APPENDIX B ARCHITECTURAL DESIGN REPORT

BUILDING J DESIGN REPORT SSD Application

Museums Discovery Centre

APPENDIX D: SDRP RESPONSE

BUILDING SIGNAGE

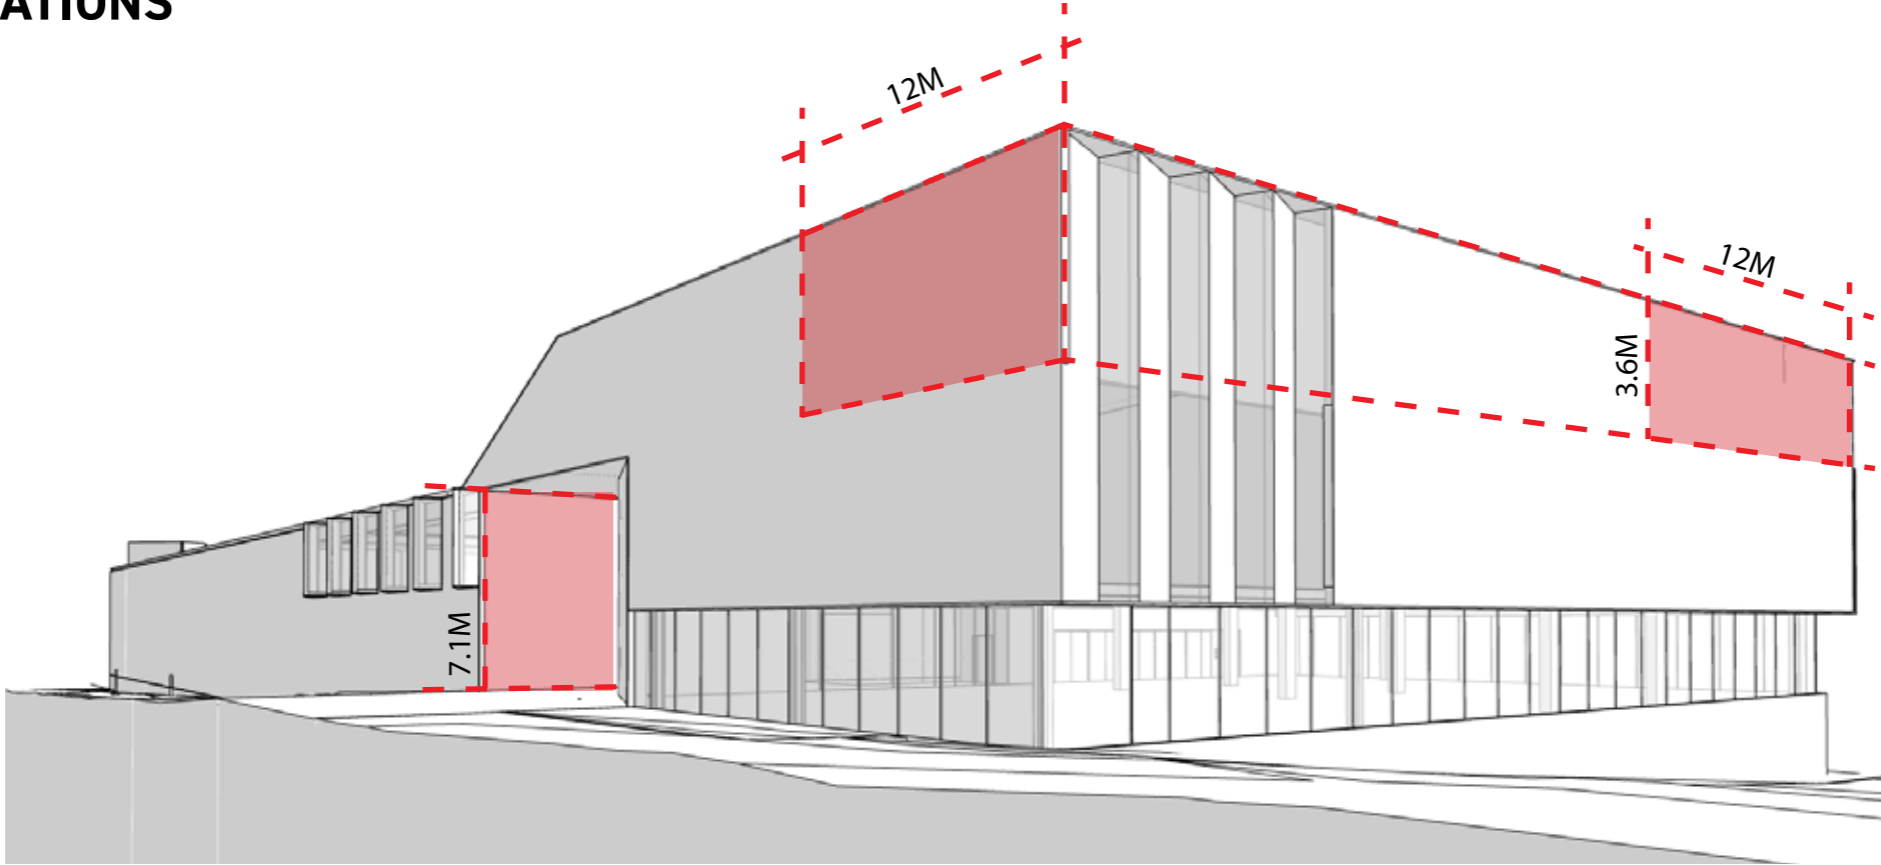
Clarify and illustrate signage proposed.

Signage zones are provided in Appendix E. The detail of the signage will be developed at the detailed design stage and included within these zones.
